## ARCHITECTURAL REVIEW BOARD STAFF REPORT

<b>Project #/Name</b>	<b>ARB-2020-90: Aldi at Albemarle Square</b>
<b>Review Type</b>	Preliminary Review of a Building Permit
<b>Parcel Identification</b>	06100-00-00-12300
<b>Location</b>	South end of the Albemarle Square Shopping Center
<b>Zoned</b>	Planned Development Shopping Center (PDSC) / Entrance Corridor (EC)
<b>Owner/Applicant</b>	Rio Associates Limited Partnership c/o Dumbarton Properties Inc./ Design Develop LLC (Kevin Schafer)
<b>Magisterial District</b>	Rio
<b>Proposal</b>	To renovate the existing building to accommodate an Aldi grocery store.
<b>Context</b>	The general context is the Albemarle Square Shopping Center. To the southwest is a vacant commercial building. To the west along Rt. 29 are two restaurant buildings, including the Texas Roadhouse, and a bank building. Other commercial development is located to the south, west and north. Residential development is located to the northeast and east.

Scale: As Noted Drawing No. A-201

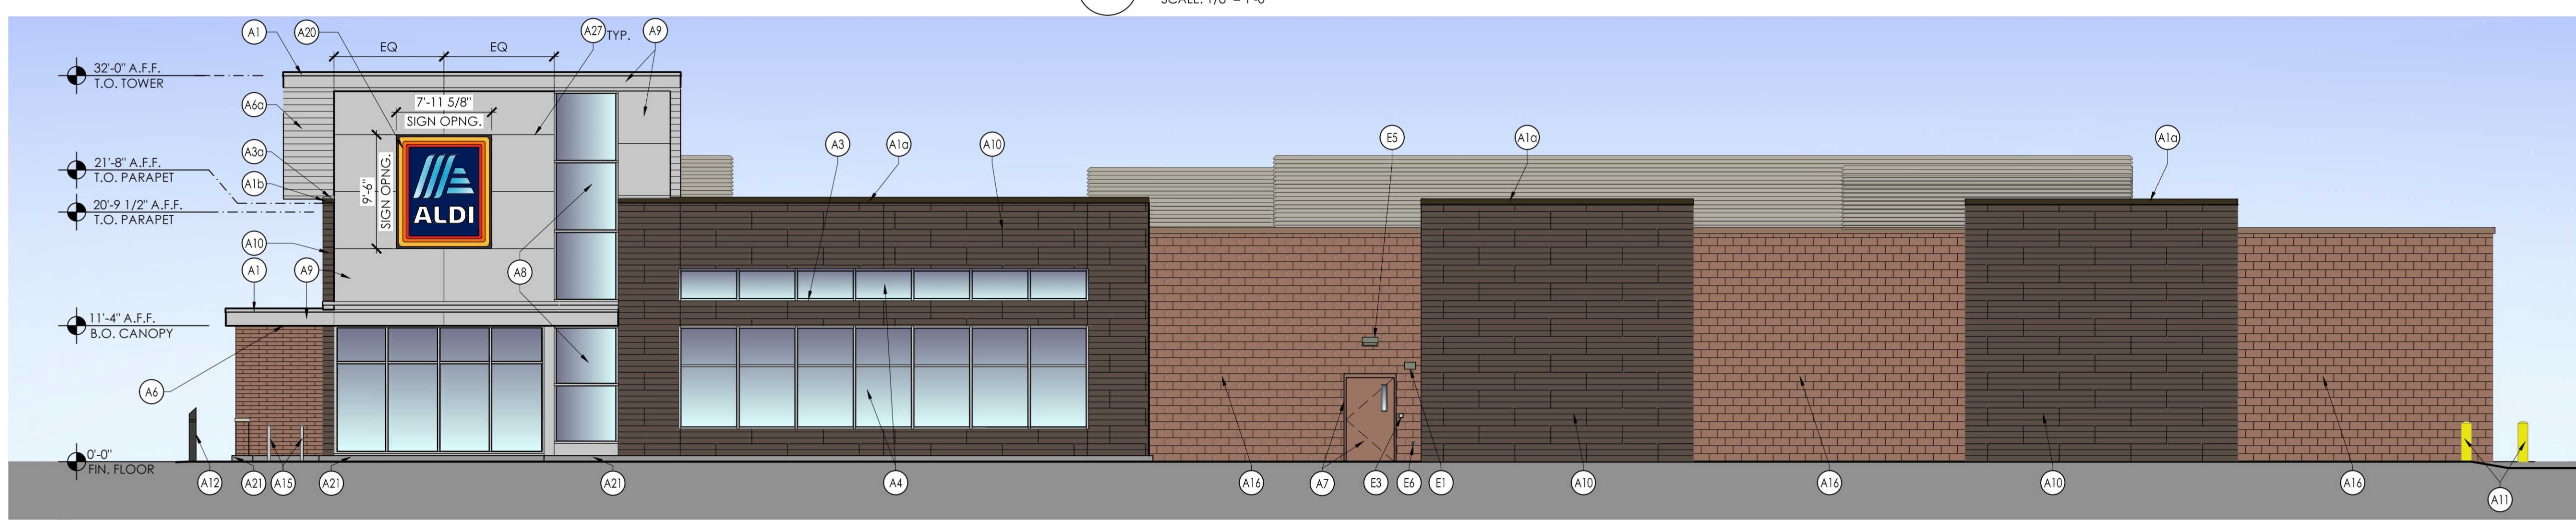
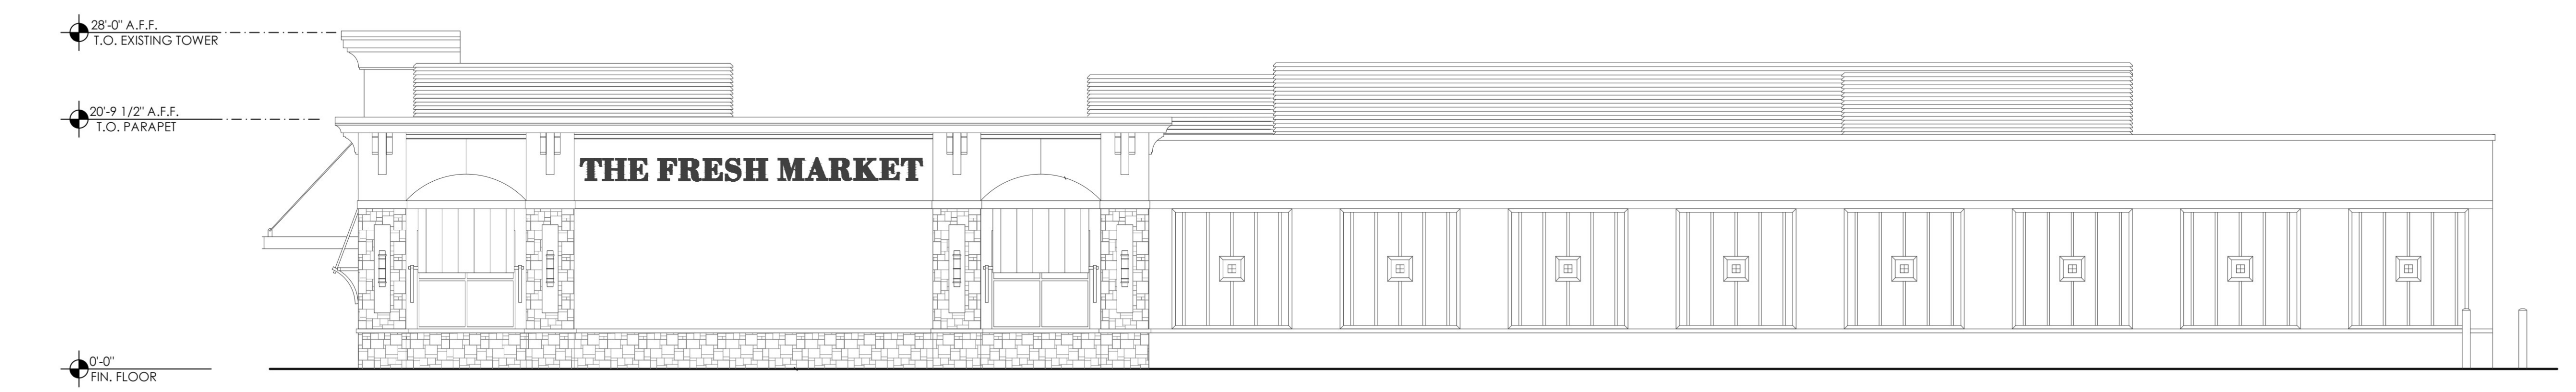
1. Revise the design to eliminate the striped effect of the alternating bays on the west and south elevations. Consider additional detailing and alternate distribution/division of colors.

2. Provide a larger sample of the silver metal panels for review. Consider an alternate color for the metal panels that is more consistent with the neutral shades of the shopping center building and the roof screen.

3. Clarify whether the paint color for the existing CMU is to match the Stanton Blend concrete masonry veneer or the proposed mortar.
4. Revise the window glass note to read, “Window glass meets the following criteria:...”

5. Revise the mechanical screen color to appear more coordinated with the proposed building colors while maintaining a background appearance.
6. Include the standard mechanical equipment note on the drawings.

Project Name: ALDI - US 29 & Rio Rd. Charlottesville, VA - EXT

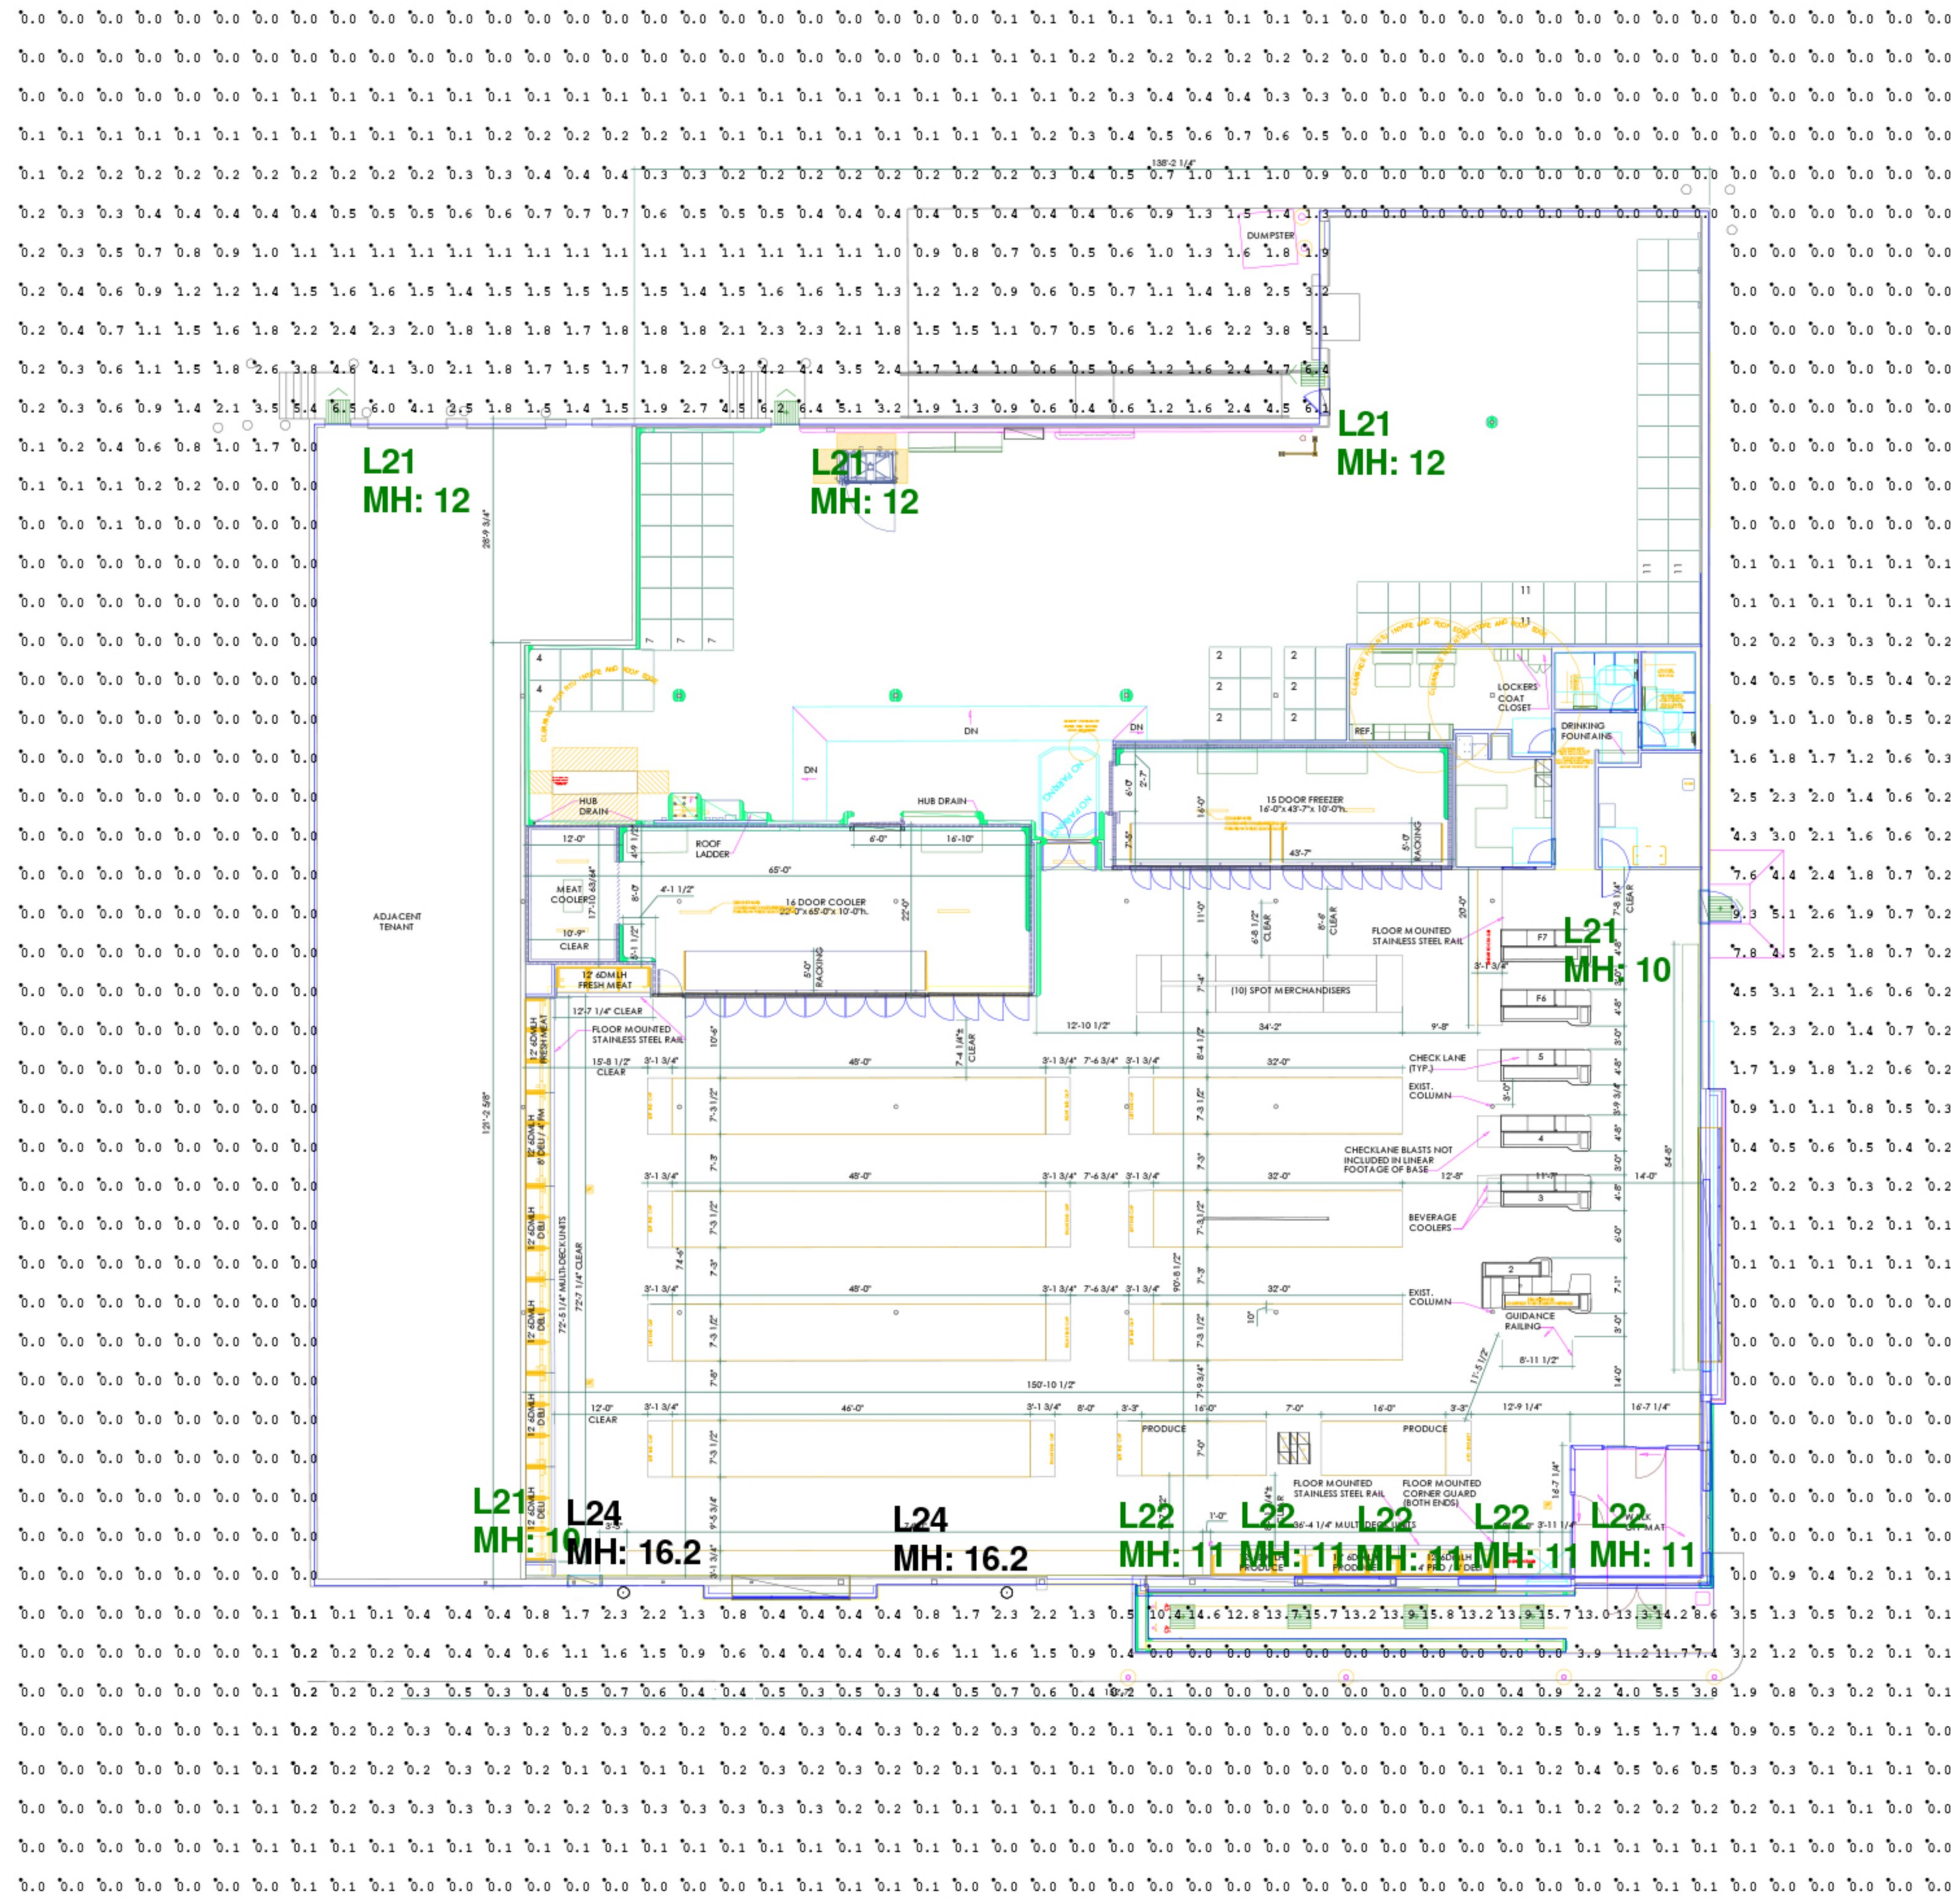
7. Revise the luminaire schedule to show the total lumens for each LED fixture and to indicate the Top Cover Lens for the wall sconce. Provide a wall sconce cut sheet whose specs match the catalog number provided in the luminaire schedule.

8. Revise the luminaire schedule to identify the color temperature for the wall sconces. Coordinate the color temperature of all fixtures to a single level between 2000 and 3000 K.

9. Add the standard lighting note to the plan: “Each outdoor luminaire equipped with a lamp that emits 3,000 or more initial lumens shall be a full cutoff luminaire and shall be arranged or shielded to reflect light away from adjoining residential districts and away from adjacent roads. The spillover of lighting from luminaires onto public roads and property in residential or rural areas zoning districts shall not exceed one half footcandle.”

10. Specify the Top Cover Lens for the wall sconces. Revise the wall sconce location to limit illumination of the wall and maximize illumination of the sidewalk.
